## ADDENDUM NO. 1

May 29, 2025

Leggett Volunteer Fire Department & Town Hall  
29 Draughn Rd  
Tarboro NC 27886

- 1 – Pre-Bid Meeting Key Notes – Dated 05-15-2025
- 2 – Pre-Bid Meeting Sign-in Sheet – Dated 05-15-2029
- 3 – RFI Log – Dated 05-29-2025
- 4 – Revision 1 Sheets – Dated 05-15-2025
- 5 – Revision 2 Sheets – Dated 05-29-2025

Project Number: 24-200  
Date: MAY 2025  
Client Code: CONDAW  
Scale (Horz.): 1" = 30'  
Scale (Vert.): N/A  
Survey By:  
Field Book:  
Drawn By: LR  
Sheet: **SP2**

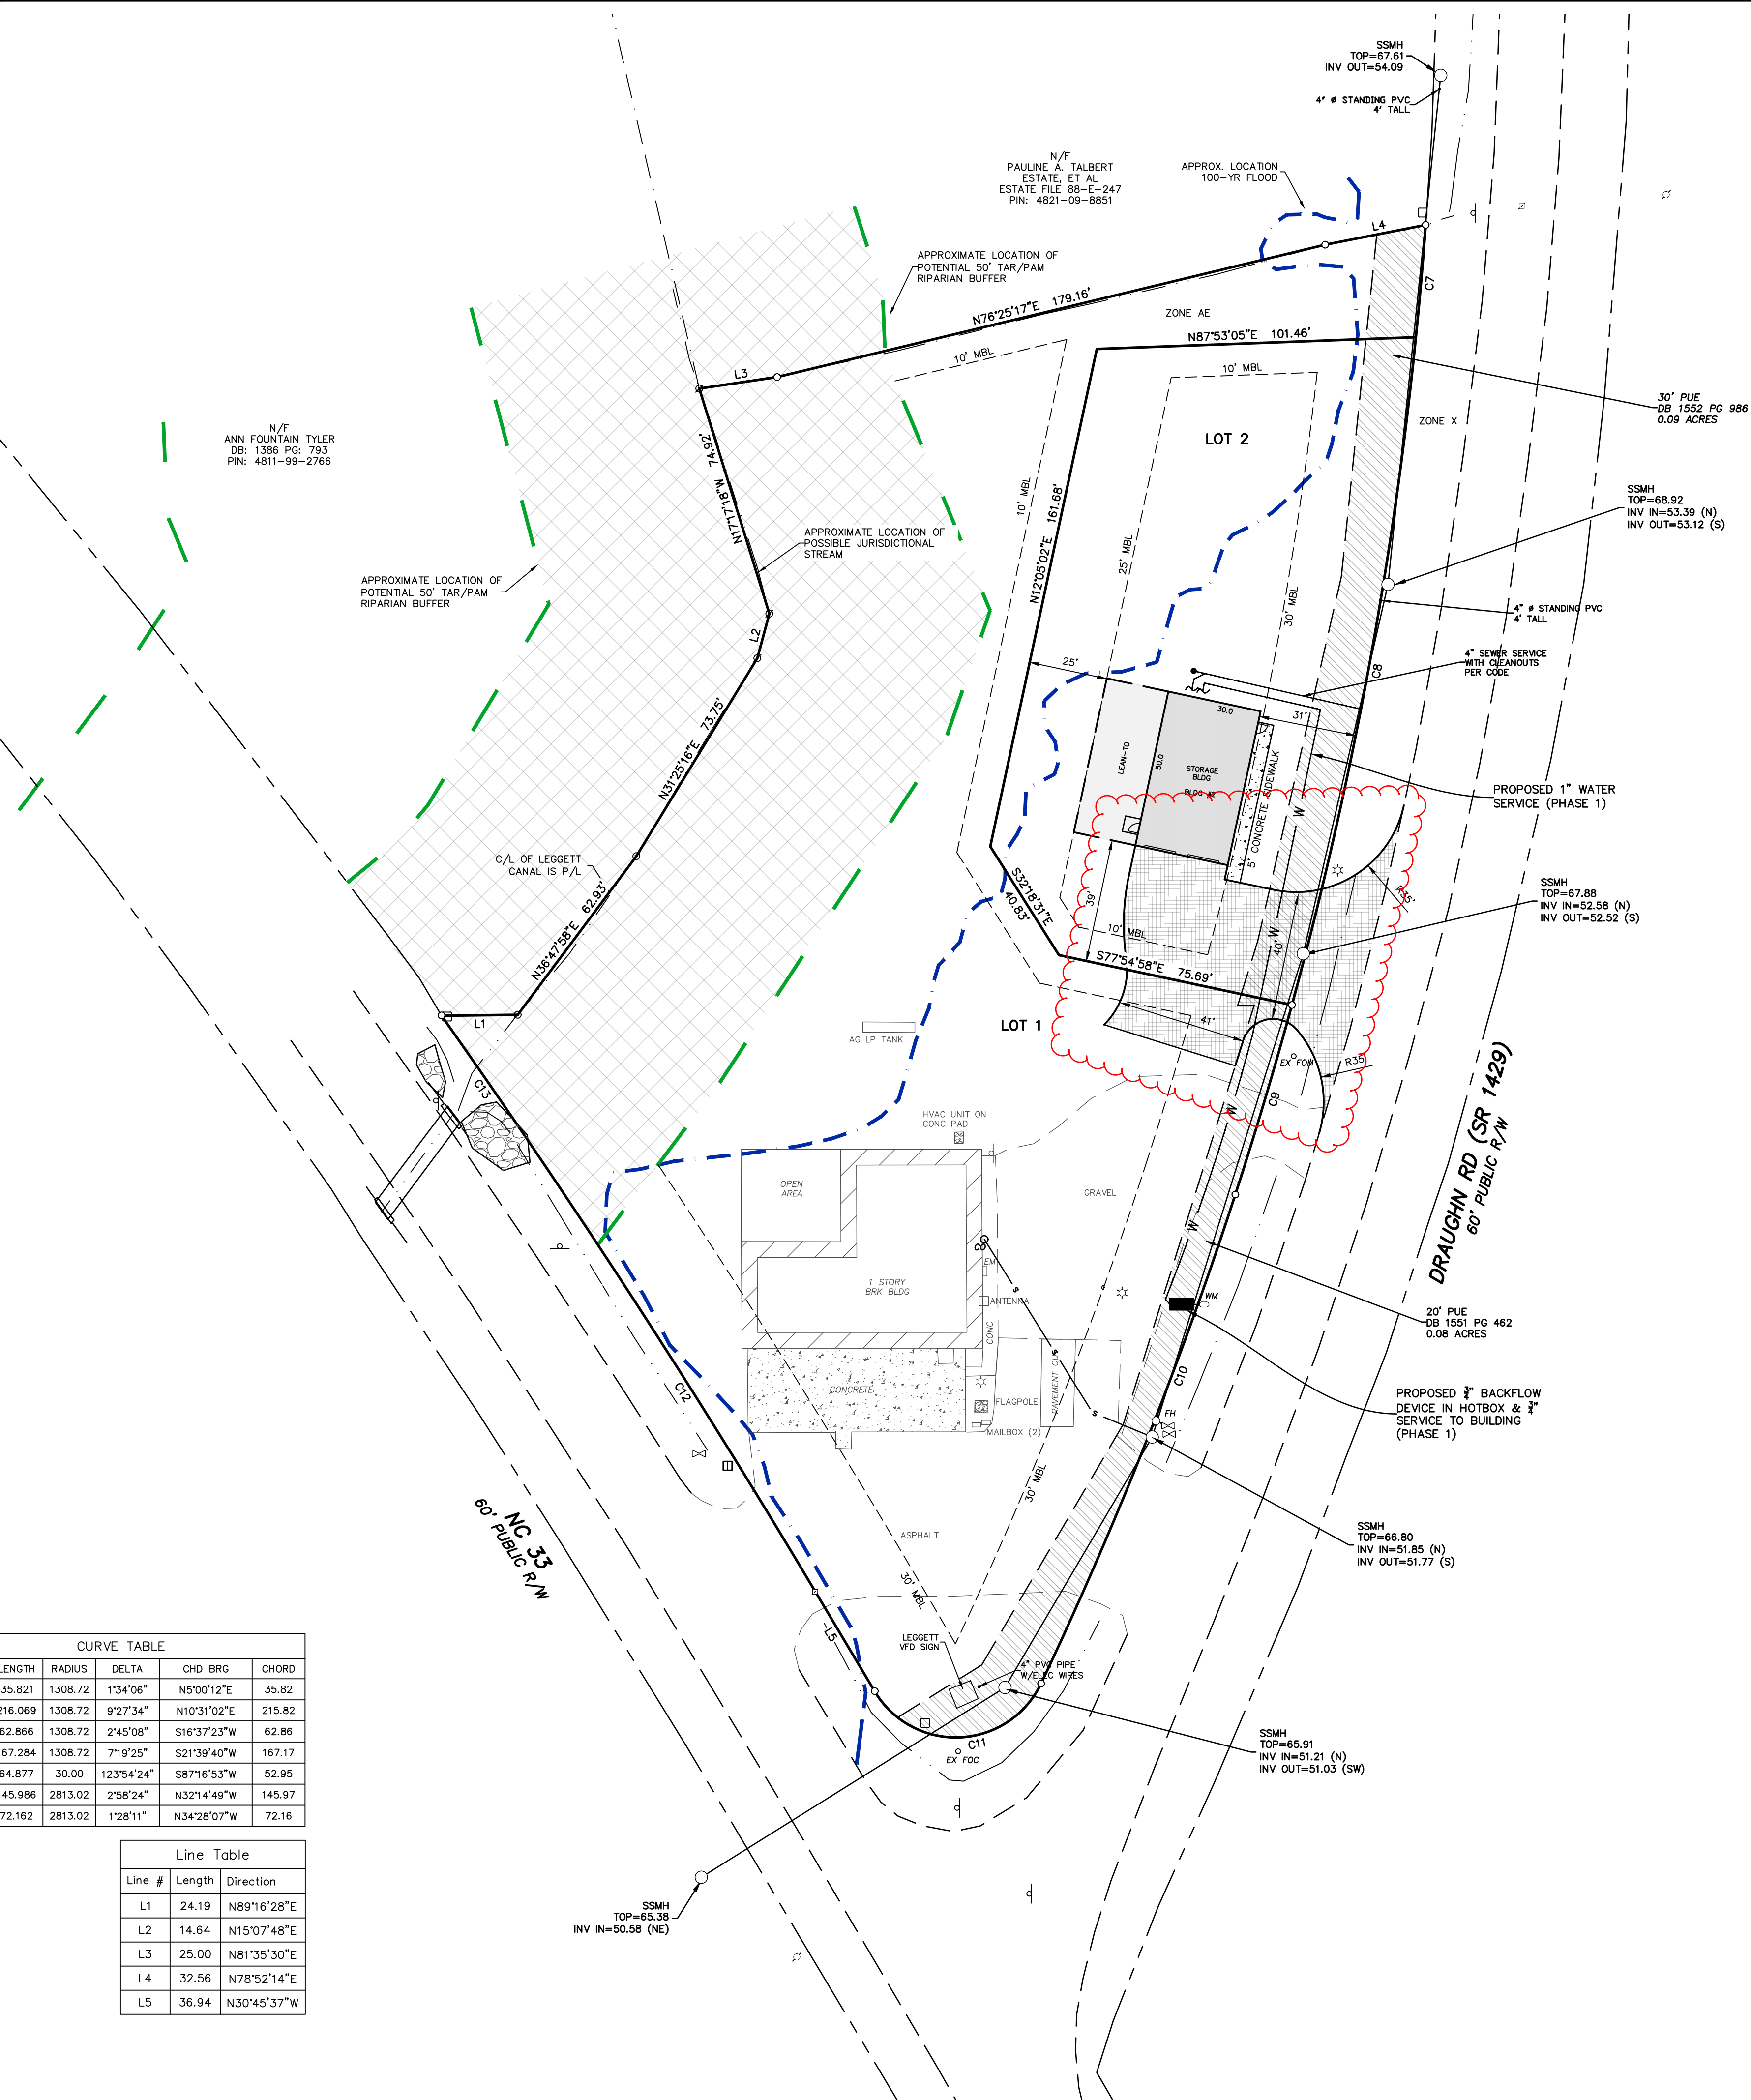
RFI #	QUESTION	ANSWER
1	When is anticipated award?	Owners are looking to award this project shortly after the bid-opening.
2	Clarify SP2 Note regarding alternate.	If deduct <u>Alternate No 2</u> is accepted the project will be completed in one phase.
3	Existing building demolition, permitting, and asbestos testing.	GC to include asbestos testing and demo permit in base bid and in Alternate No 5
4	Please confirm that the existing building must be demolished in order to construct the new fire station. As shown on SP 1 and SP 2 the existing fire station is in the same location as the proposed new fire station, therefore the existing structure must be demolished prior to construction of the new fire station. If this is not the case, please clarify.	The existing building will need to be demo'd prior to construction for the new building on Lot 1.
5	Is the antenna next to the building, the flagpole, and mailboxes part of the demo of the existing building?	Yes

NOTE: IF DEDUCT ALT. 2 IS ACCEPTED, PROJECT WILL BE COMPLETED IN ONE PHASE.

GENERATOR CONCRETE PAD DETAIL  
NO SCALE

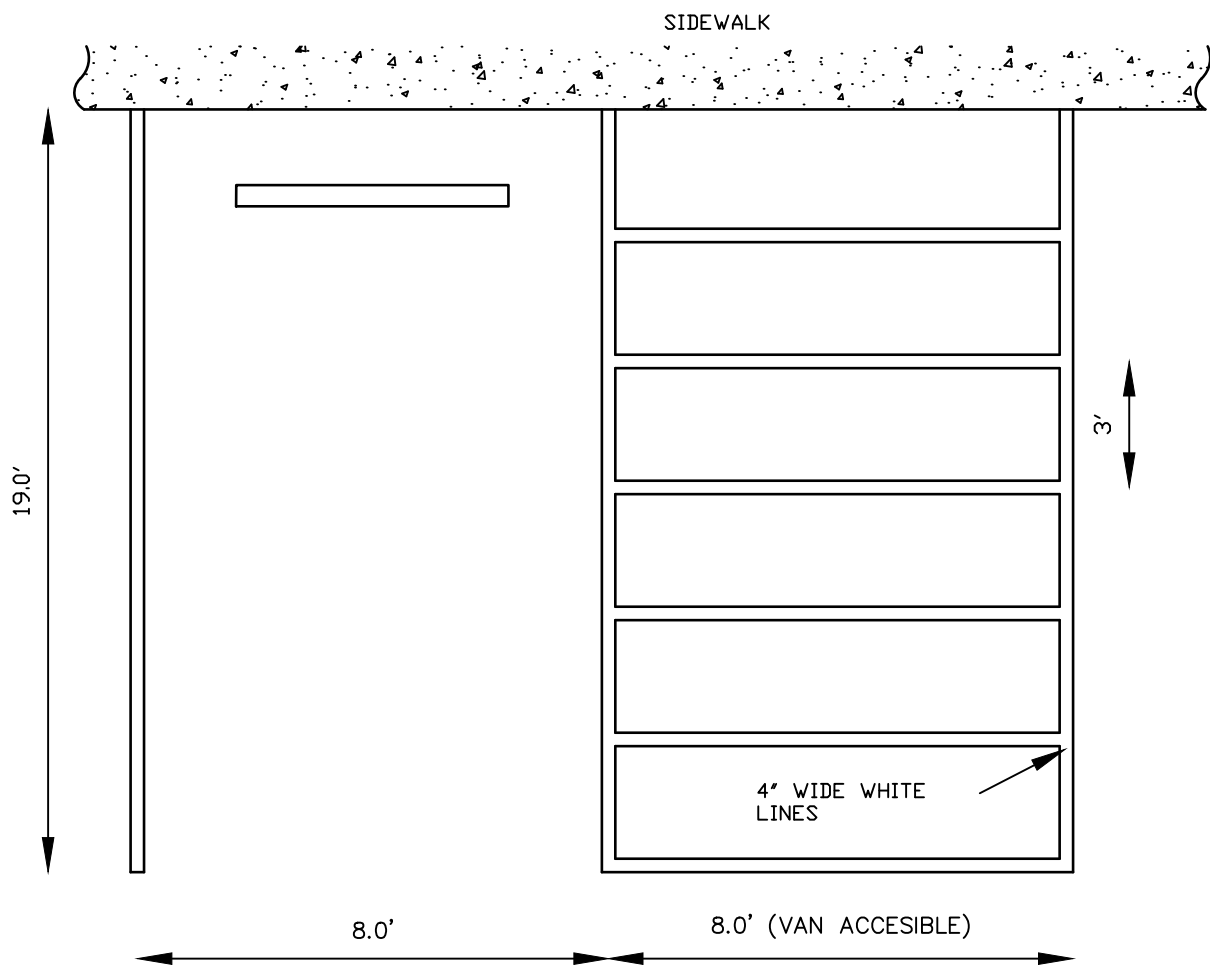
31	Sheet E-2 shows honeywell "e3" system, who furnishes controller is electrical contractor responsible for control raceway?	All wiring by the electrical contractor. Mechanical Contractor shall furnish and install the "E3" system devices
32	What are the specs on Automatic Transfer Switch?	Auto Transfer Switch shall be provided by the generator manufacturer and shall be suitable for the generator. Contractor shall review generator specs & ATS with the manufacturer prior to ordering equipment.

GENERATOR PAD CALCS	
GENERATOR WEIGHT (LBS):	1900
CONCRETE DENSITY (FT <sup>3</sup> ):	150
FOUNDATION WIDTH (FT):	3.92
FOUNDATION LENGTH (FT):	7.95
MIN. DEPTH OF BASE (IN):	6.1
DESIGN BASE DEPTH (IN):	6.5
